Re: Turkey Point Units 3 & 4  
Docket Nos. 50-250 and 50-251  
Hot Channel Factor Normalized Operating Envelope

SAFETY EVALUATION

FIG. 3.2-3

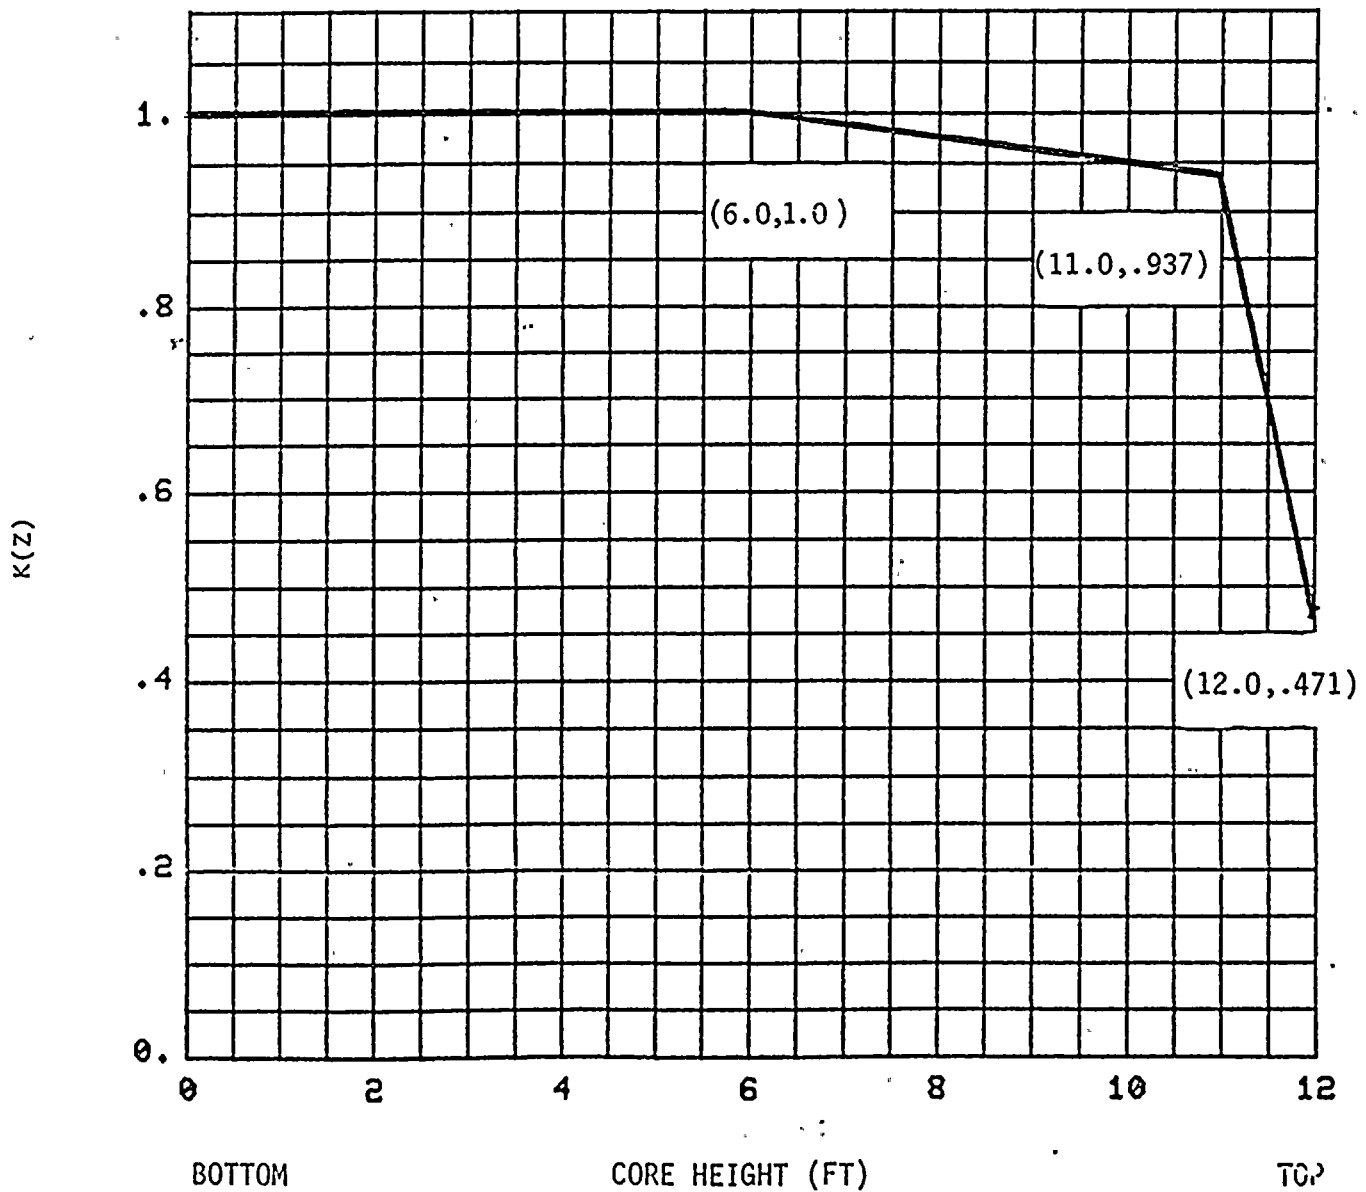
Following flux mapping at Turkey Point Unit 3 a discrepancy was noted in Figure 3.2-3, Hot Channel Factor Normalized Operating Envelope. The discrepancy was in the conservative direction, and while it posed no safety concern, the curve restricted power output of the unit. The proposed Technical Specification amendment substitutes the existing curve with that in the WCAP prepared for Cycle 8, our current cycle (WCAP's 10024 and 10056). This substitution has been discussed and agreed upon between Westinghouse and the NRC Staff.
